REGIONAL REVIEW FINDING

Submitting Local Government: Fulton County
Name of Proposal: Riverside Park

Review Type: Development of Regional Impact

Preliminary Report:	July 17, 2006	DEVELOPMENT OF REGIONAL IMPACT REVIEW REPORT	Project:	Riverside Park #1132
Final Report Due:	August 18, 2006		Comments Due By:	July 31, 2006

Title:
ZONING PLAN

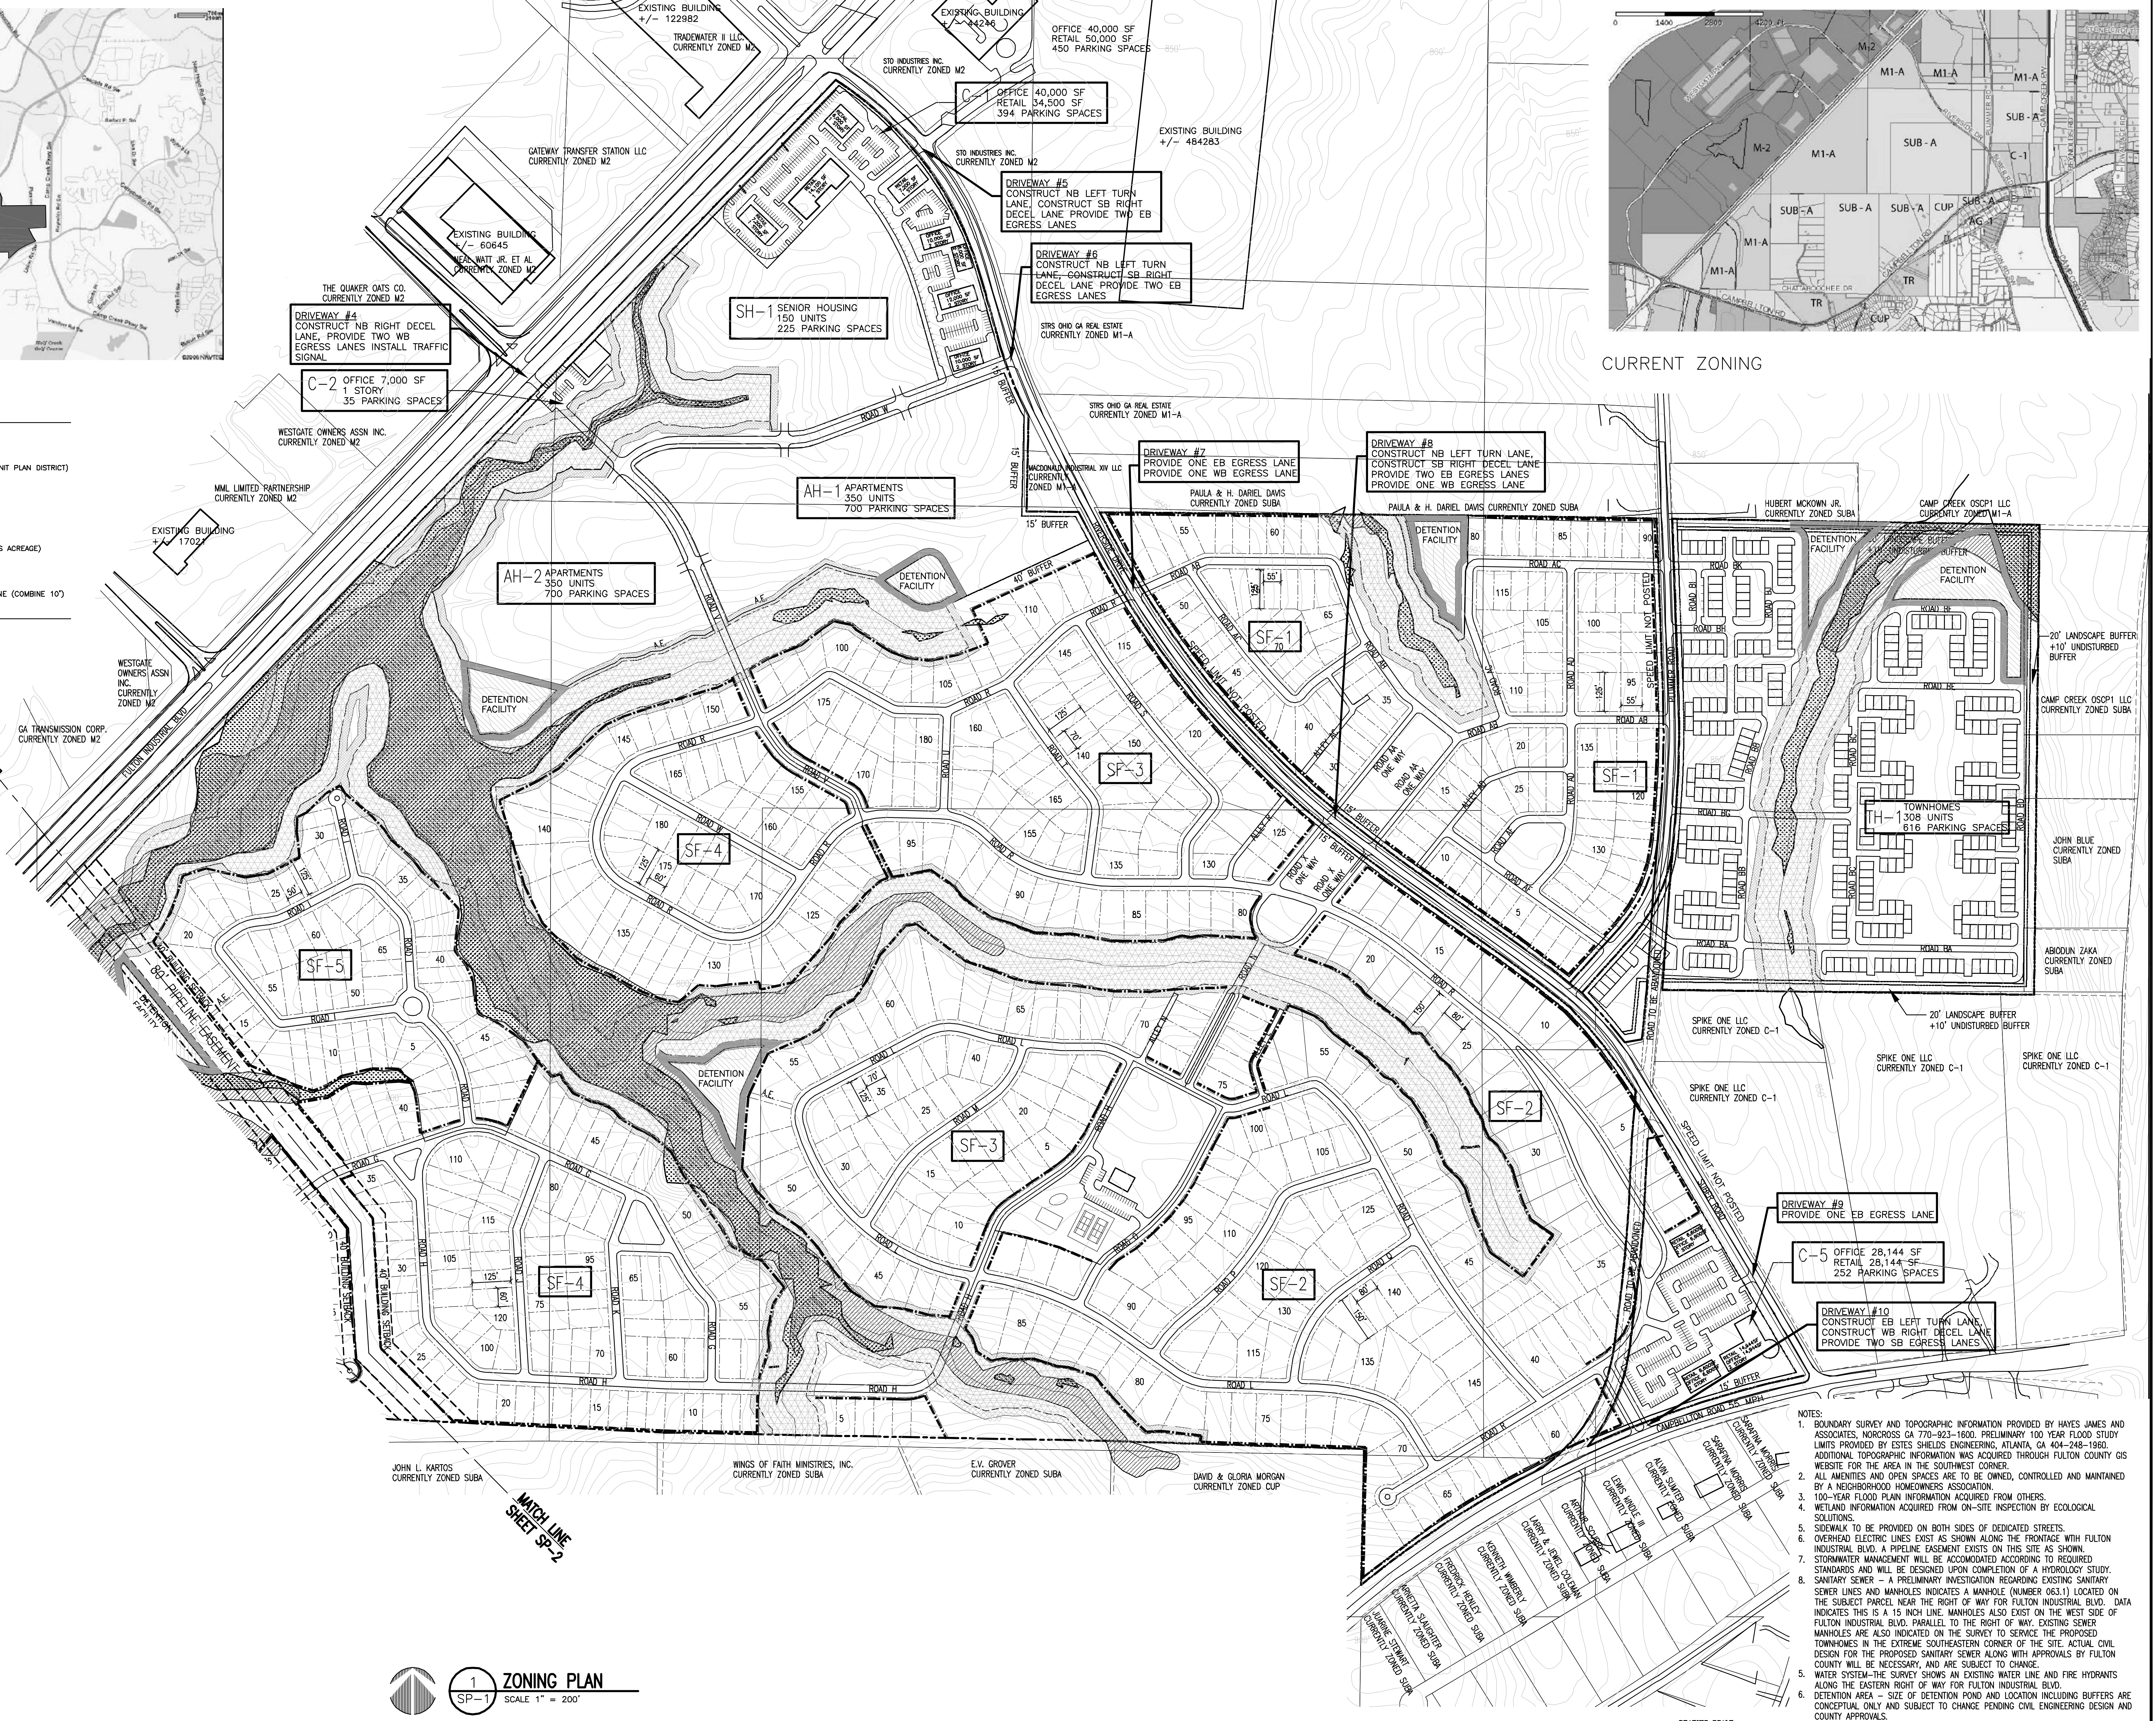
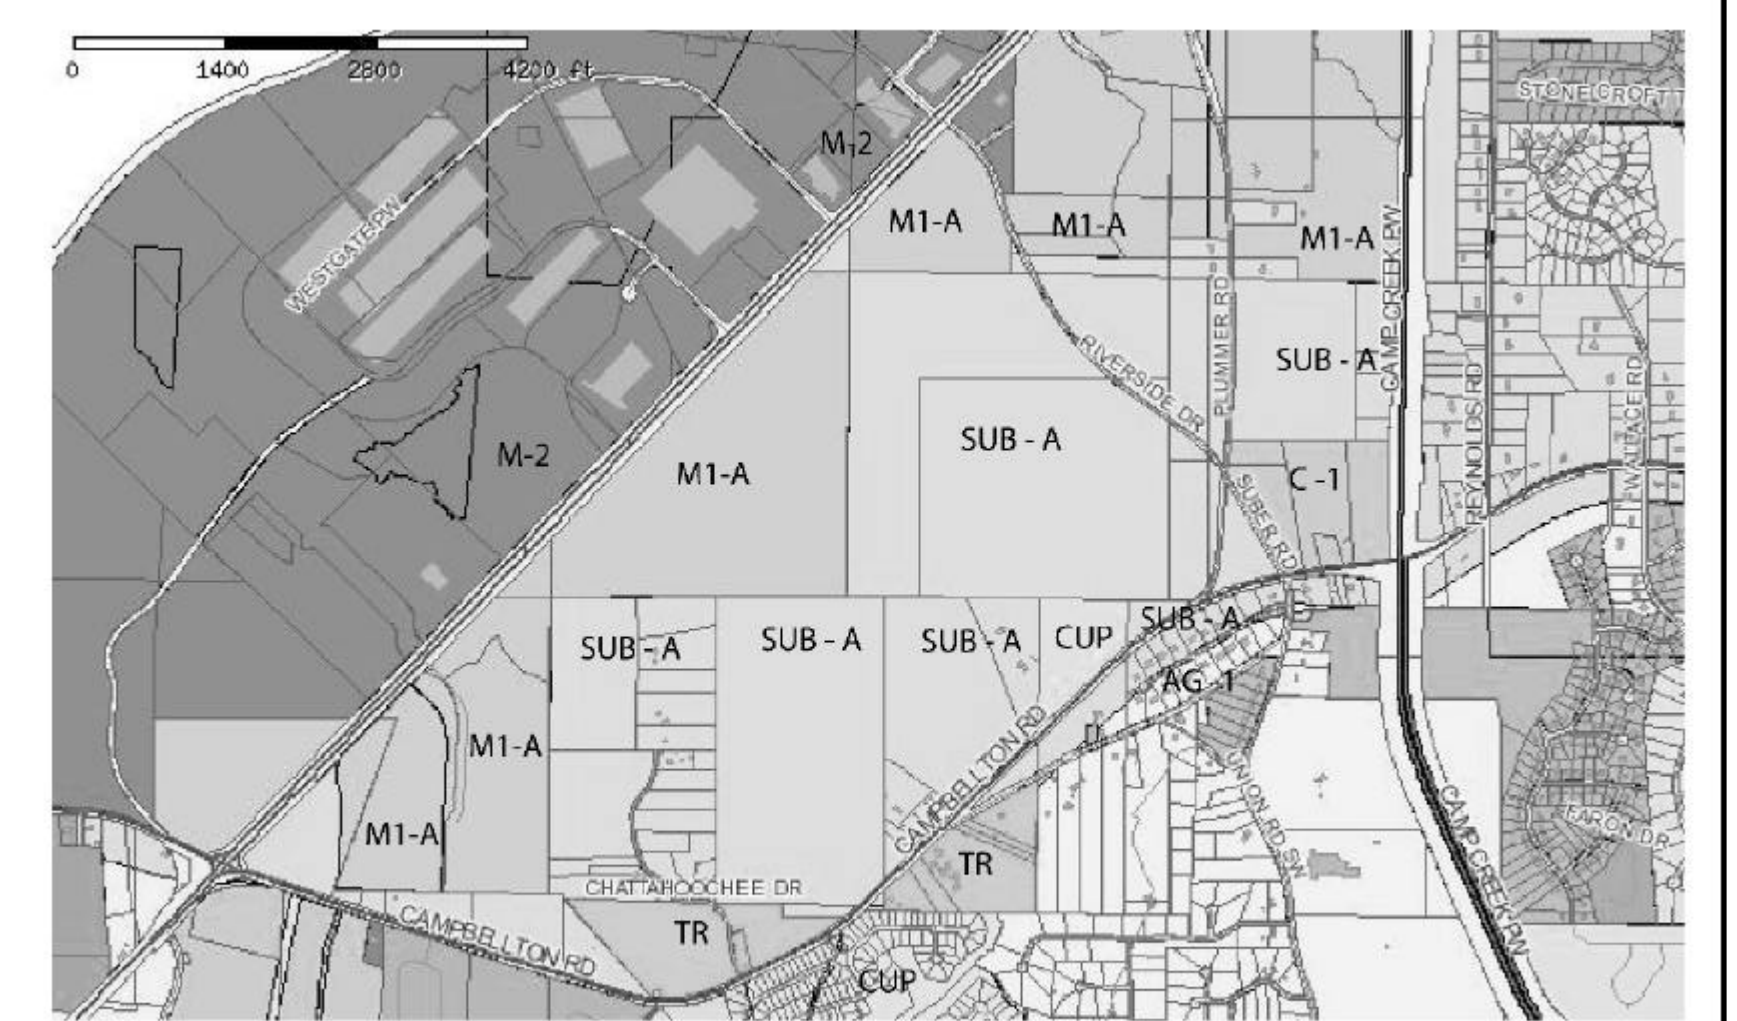
ARC staff strongly recommends that the development include a trail system that would potentially connect with a multi-purpose trail throughout the Sandtown Community. Although sidewalks are provided on both sides of all internal streets, ARC recommends providing multi-purpose trails that would provide short-cuts and alternative paths to pedestrians and bicyclists within the community that could connect with a larger trail system for the community.

The property is not within the 2000-foot Chattahoochee River Corridor but it is located in the Corridor watershed. The USGS 1:24,000 coverage for the project area shows several blue line streams crossing the project property. One stream is a tributary to the Chattahoochee River. The rest are tributaries to that stream. As required under the Metropolitan River Protection Act, the property is subject to the requirements of the Fulton County South Chattahoochee Tributary Buffer Ordinance. In addition, Metropolitan North Georgia Water Planning District requires local governments to adopt a stream buffer ordinance at least as protective as the model ordinance developed by the District. The Fulton ordinance, which covers both the Water District and Metropolitan River Protection Act requirements, requires a 75-foot undisturbed buffer and an additional 25-foot impervious surface setback on most streams. These buffers are shown on the streams on the property.
